**AGENDA
ARCHITECTURAL COMMISSION
REGULAR MEETING**

ARCHITECTURAL COMMISSION STAFF REPORT

Subject: 2798 IL Route 53

Requests: New Commercial Structure

SOUTH ELEVATION
SCALE: N.T.S. 4
SP1.1

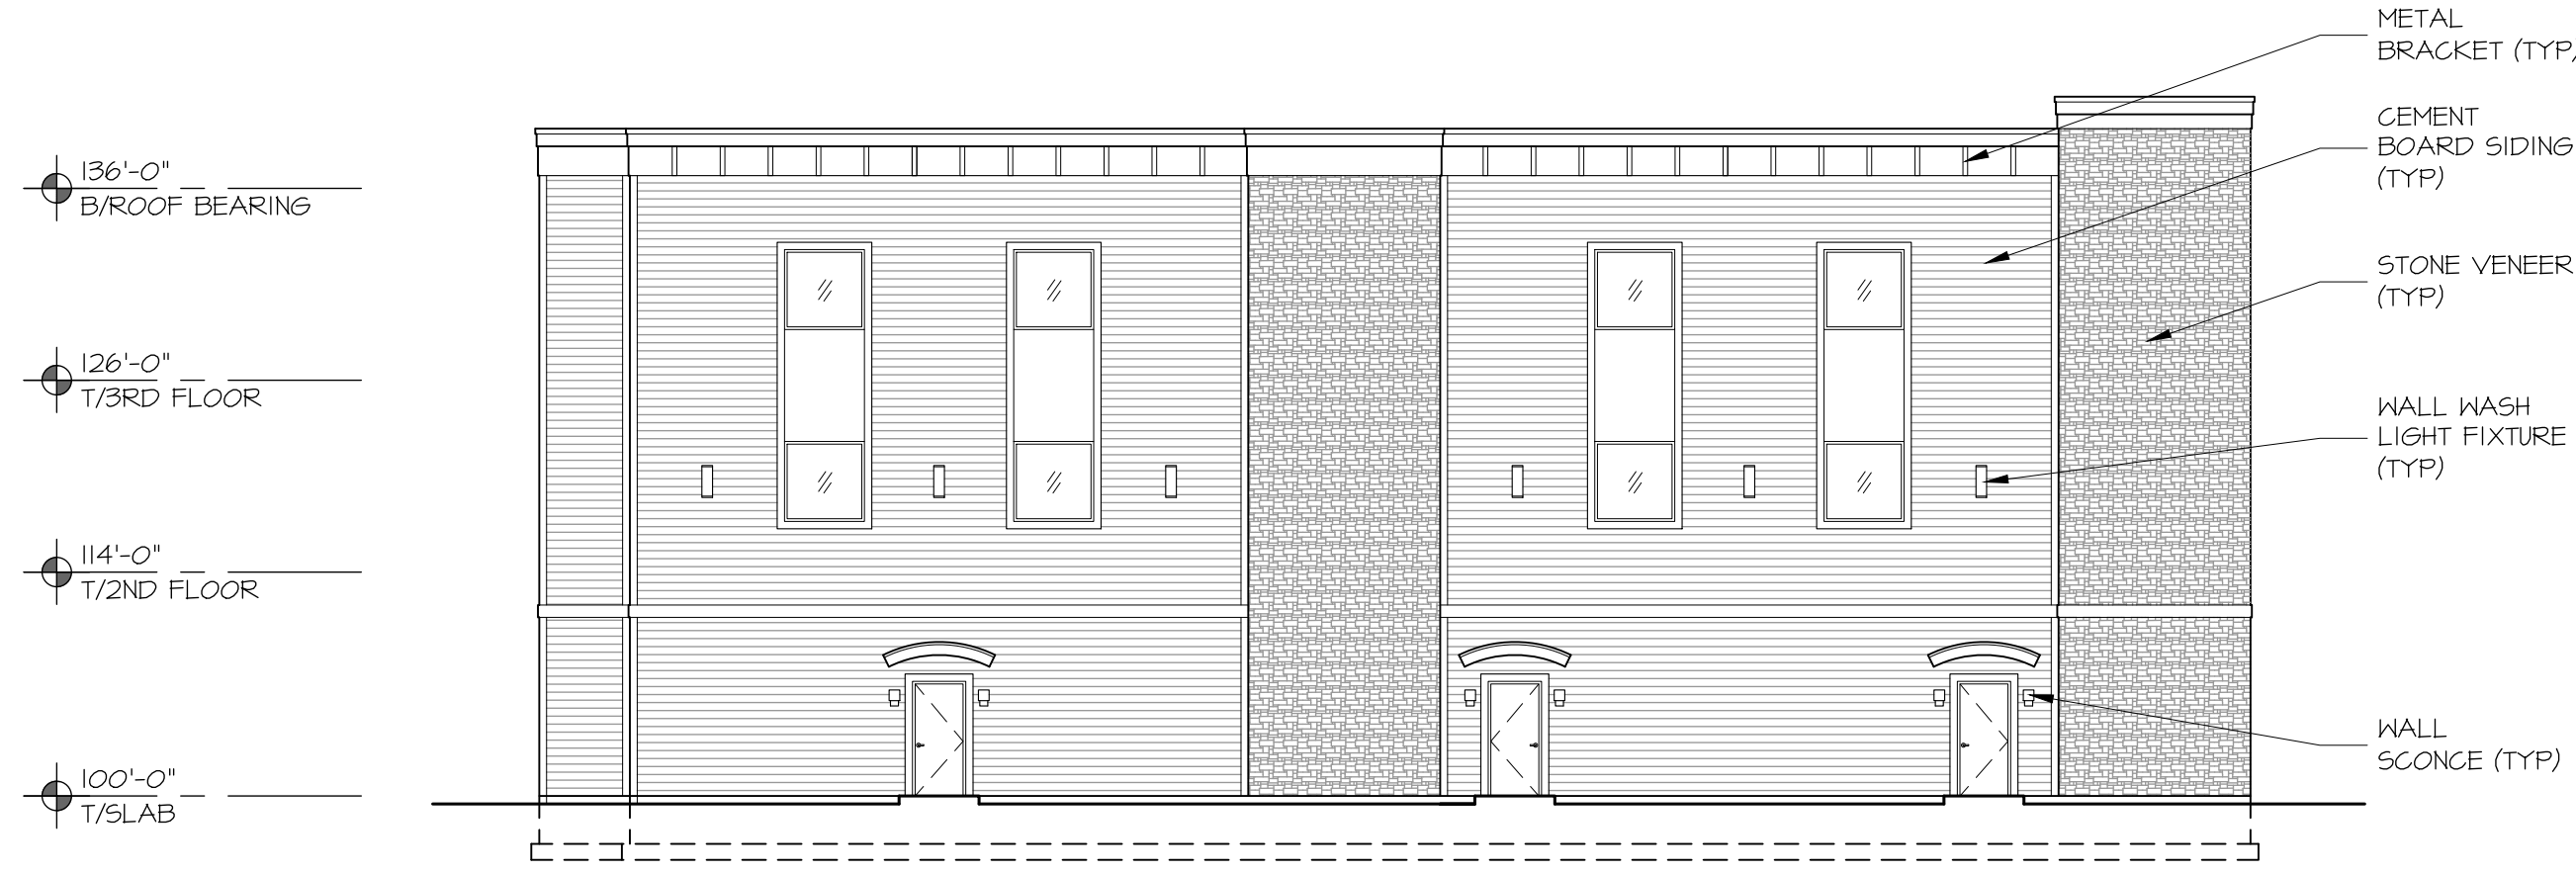
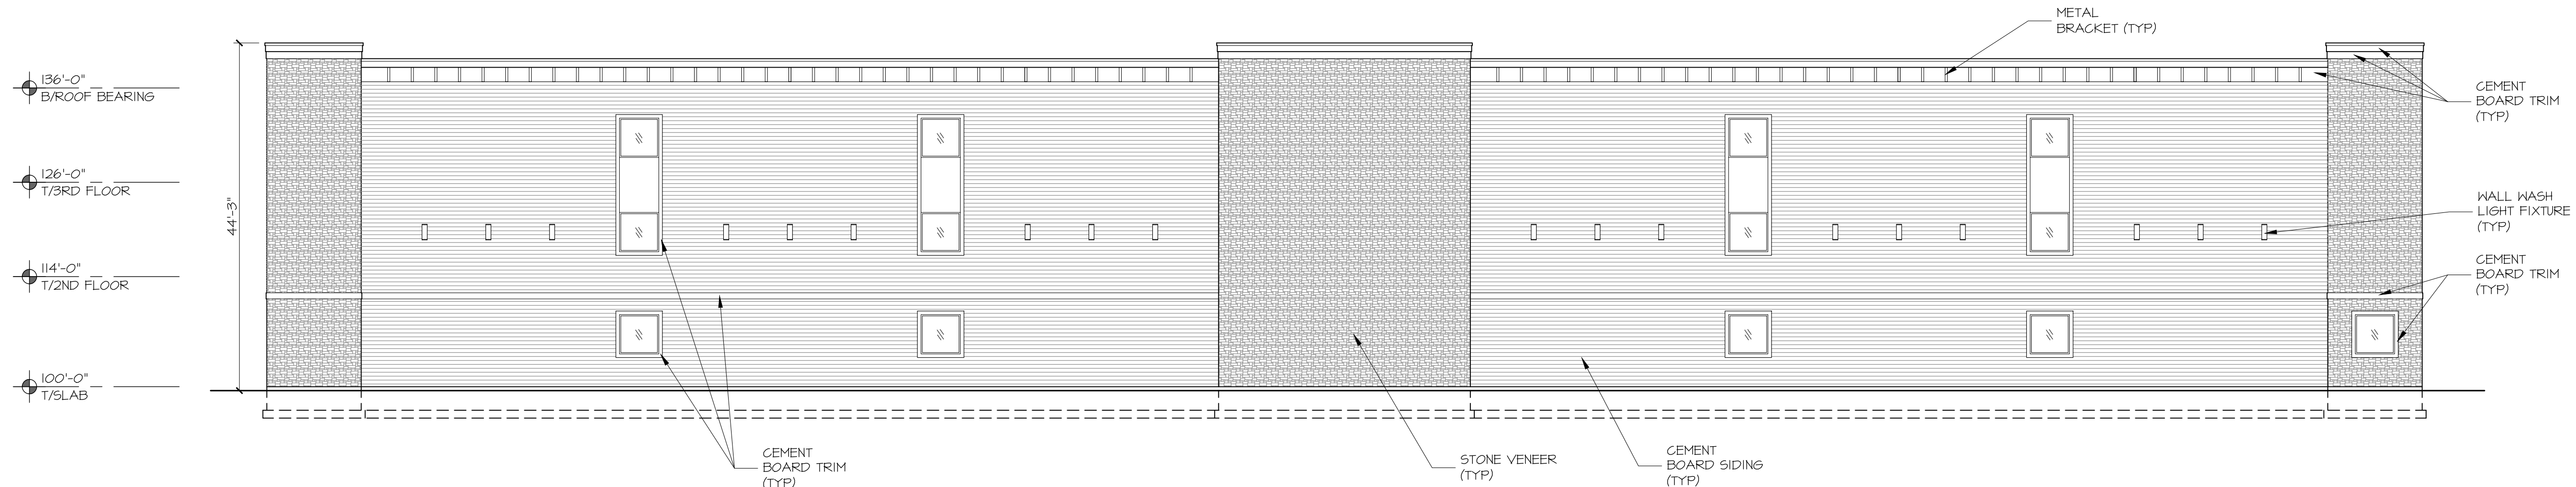
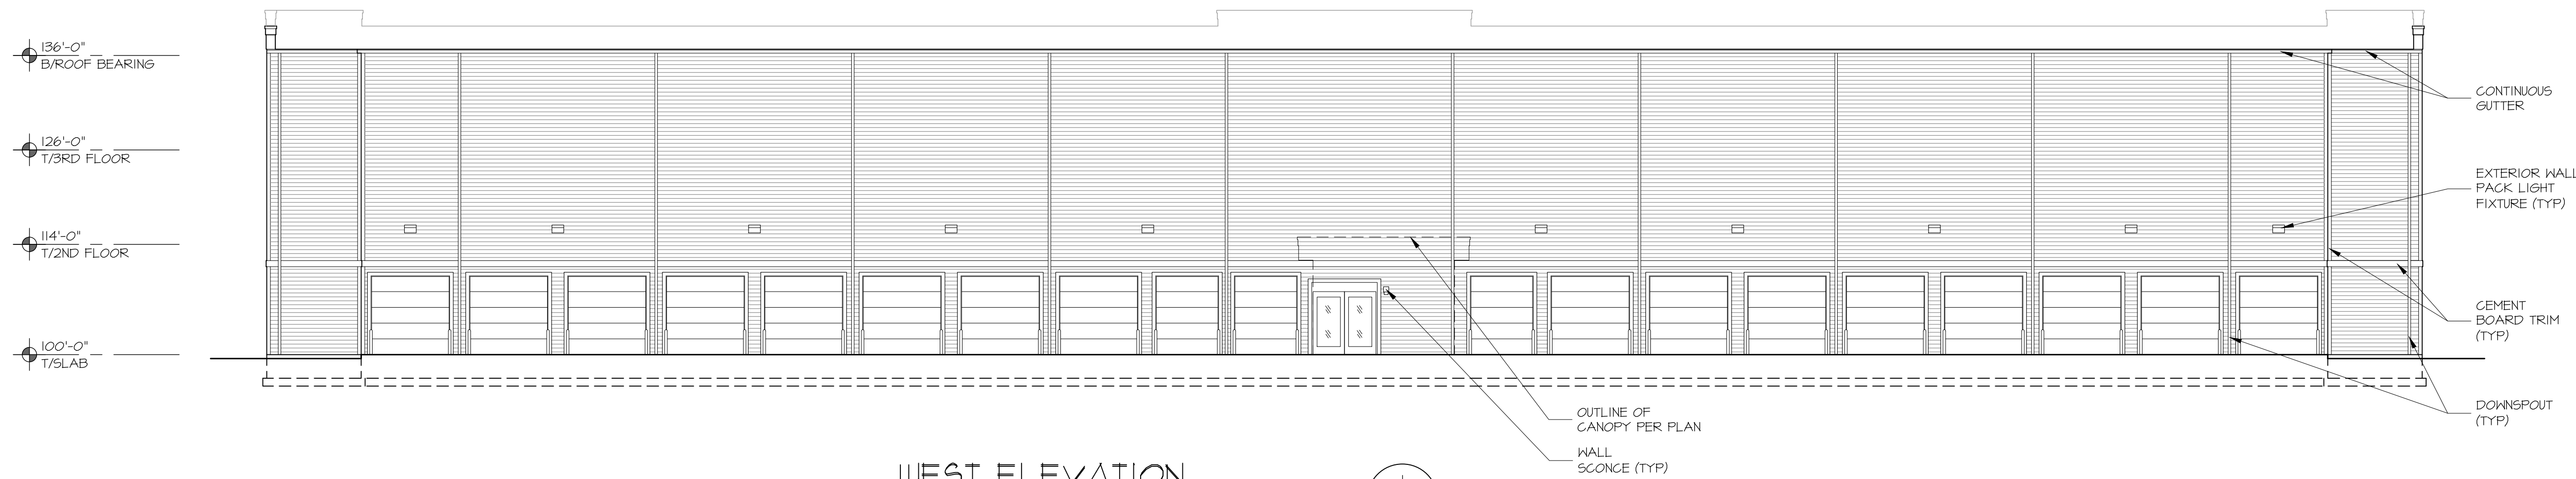
The Architectural Commission first considered the Petitioner’s proposal at its May 16, 2022 meeting. Minutes from that meeting are included as an attachment to this report. During the previous meeting, the Commission discussed the proposal at length and made numerous recommendations to more closely reflect design themes from other, existing commercial developments within the Village. At the conclusion of the meeting, the Commission voted unanimously to require further review by the Architectural Commission with the following changes recommended:

1. Increasing the roof pitch of the towers;
2. Consideration of a third tower;
3. Additional masonry or similar materials on the lower level of the building;
4. Enhancing the delineation between the levels of the building through the use of variations in material, canopies, or textures;
5. Recommended window placements and window enhancements such as trim or sills;
6. Additional landscaping along the east façade and northwest property line; and
7. Reduction in metal siding and additional texture to any metal siding used.

As revised, the proposed self-storage facility has a building footprint of 28,097 square feet and is three stories tall, resulting in a total area of 84,291 square feet. Building articulation is provided at the two ends and at the center of the building in the form of stone ‘towers’. The building height tops out at 44.3 feet from grade. The building fronts Route 53 with parking and loading spaces located behind the building. The building is setback from the front property line 30.8 feet. The property to the north is part of a large residential estate and is contemplated as a potential redevelopment site. A pond is presently located on the portion of this estate immediately west of the subject property. A commercial development, anchored by Menards, is located to the east. Several outlots remain within this development. The far southern corner of the property, where it comes to a point, is adjacent to the Lake Cook Road / Route 53 intersection.

The exterior of the building would be sided on all sides with cement board siding, accented with stone veneer at the tower features. Cement board trim would encase the windows. Metal brackets would provide a cornice feature at the roofline. Nineteen overhead doors would be located on the back side of the building.

The AC should consider whether the materials used, and overall design of the proposed structure aligns with the character of new construction projects for the Village of Long Grove. The AC should comment on the overall design as presented. The comments of the AC will be taken into consideration with any other required action.

Staff recommends that the AC make any approvals conditional upon Village Board review and approval of any zoning petitions required to complete the project.

LANDSCAPE PLAN

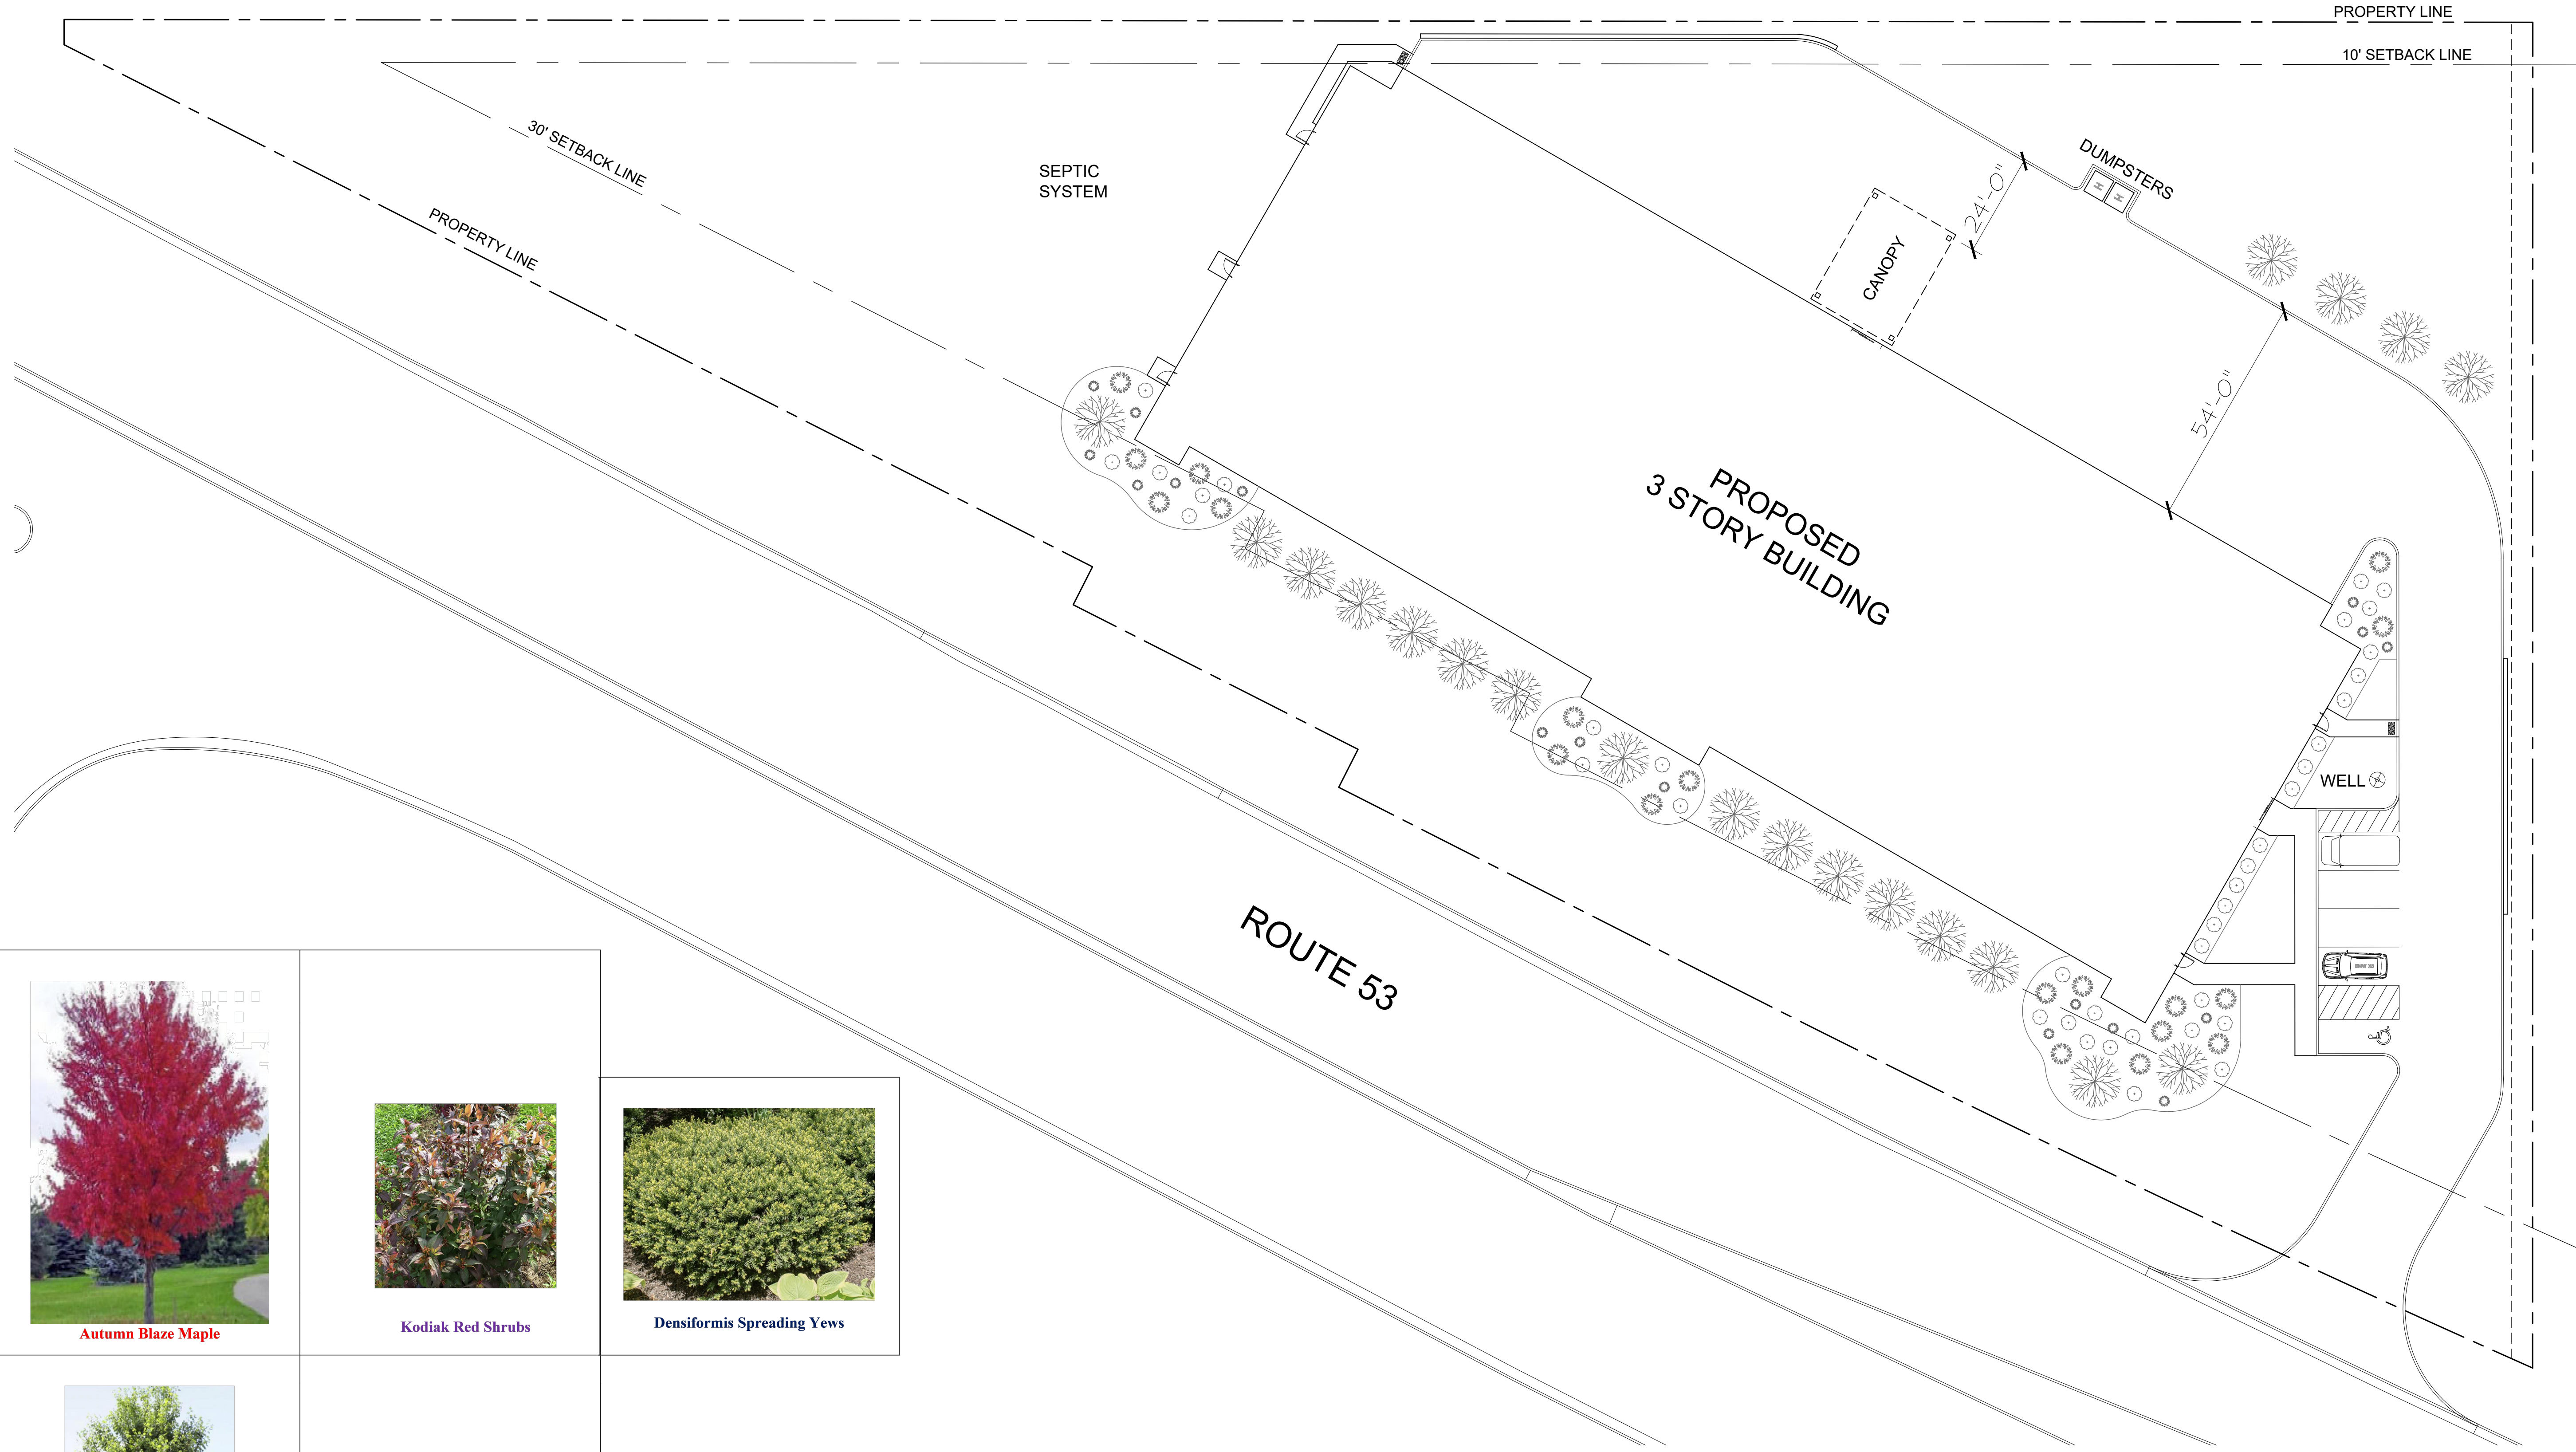
A landscape plan was also provided by the Petitioner. This plan shows one species of tree (Autumn Blaze Maple) and four species of shrubs used around the property, mostly planted around the front and side foundations.
